# Zone 3 : St Giles Circus South 7 Denmark Street Basement Modifications Design + Access Statement

Plan overlay - Consented basement with existing site constraints

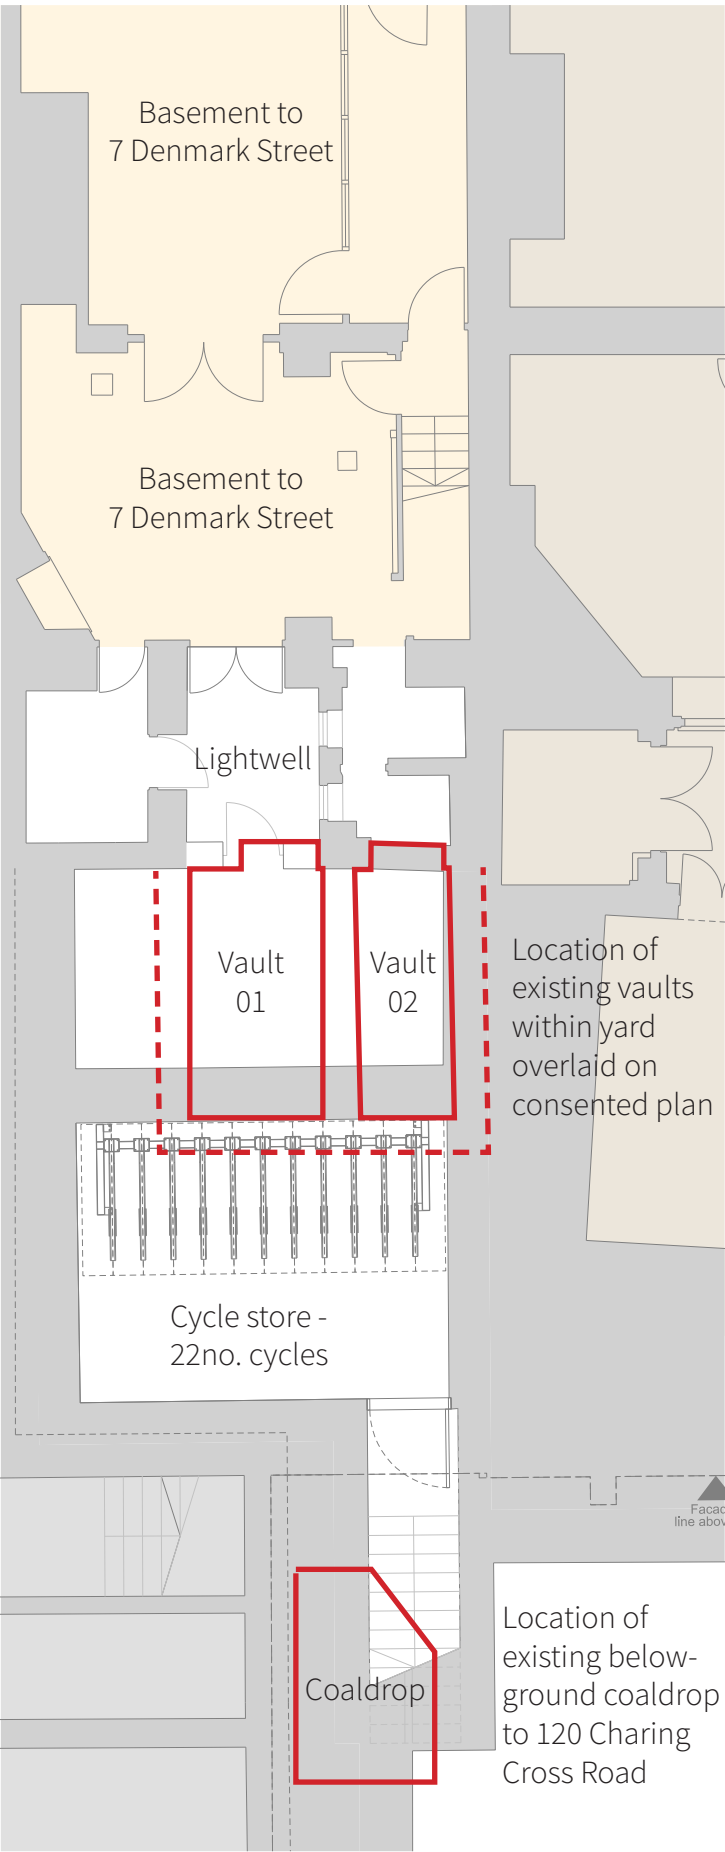
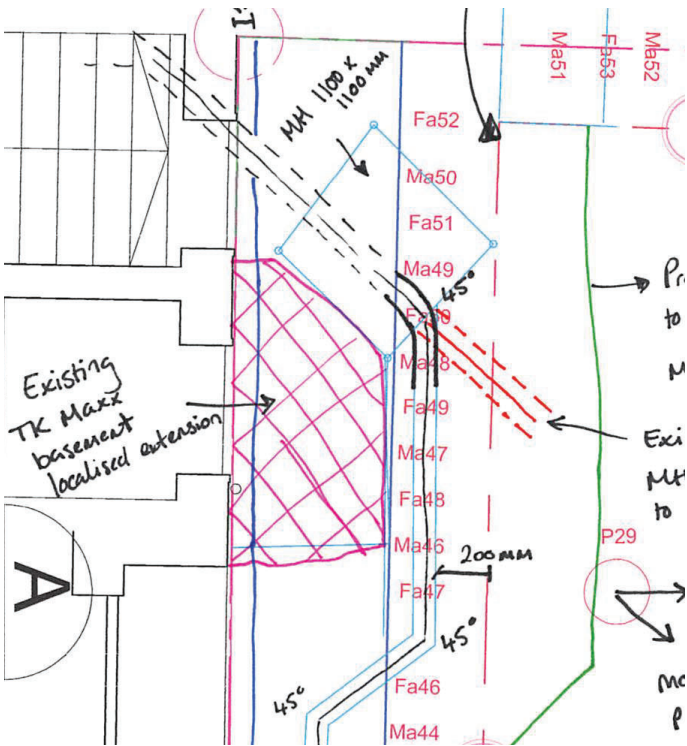
Existing vaults within 7 Denmark Street rear yard

These were uncovered in April 2019. Camden Conservation were notified and a site visit was held between ICA and Camden on 11/04/2019 to agree a revised basement strategy for this location. Attendees:

- The vaults are of interest and should be retained.*
- The lid of the failed vault arch should be re-instated.*
- The proposed new basement works that are consented are therefore reduced in footprint.*
- The reduced level dig for the new works can continue behind the mews brick wall.*
- The foundations solution to three sides of the new basement can continue.*
- The interface with the back of the vaults would need re-visiting with a follow up site visit in the next few weeks.*
- It is also likely to be acceptable to form a door opening in the back of the vaults to connect with the new space. Details to be agreed.*

Existing coaldrop to 120 Charing Cross Road

During excavation works in Book Mews to form the basement space and drainage diversion associated with 4 Flitcroft Street, a below-ground former coaldrop structure was uncovered.

This structure’s location resulted in the need to realign the below-ground drainage routes and modify the perimeter piling line of the new basement structure within Book Mews.

Another result of the coaldrop’s location is a clash with the proposed access stair for the new cycle store in 7 Denmark Street. The structure for the coaldrop sits directly within the structural zone to form the stair.

Basement floor plan showing proposed arrangement

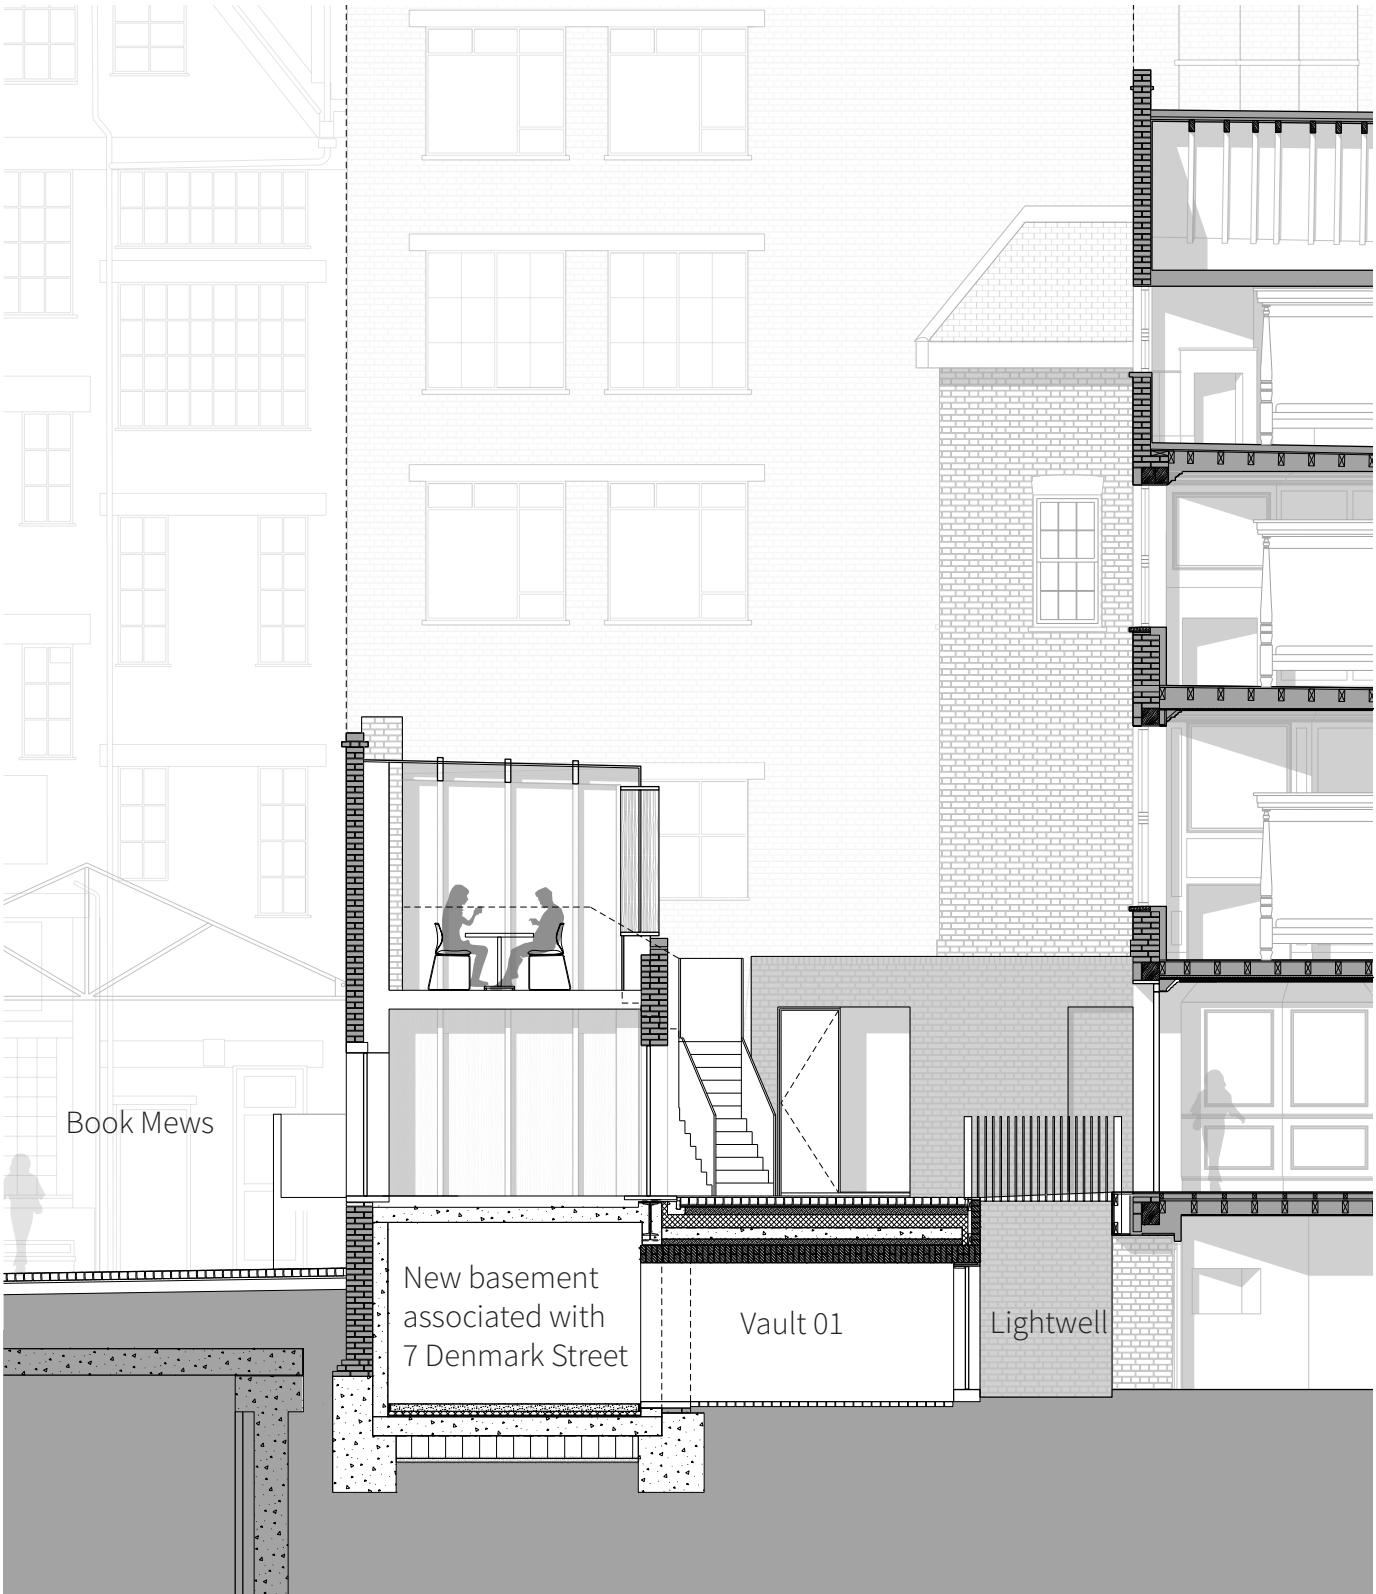
As a result of the uncovered site constraints, the basement proposals and extents have been adapted to retain the existing historic vaults to 7 Denmark Street and the access stair from Book Mews has been omitted.

Stair access to cycle store from Book Mews omitted
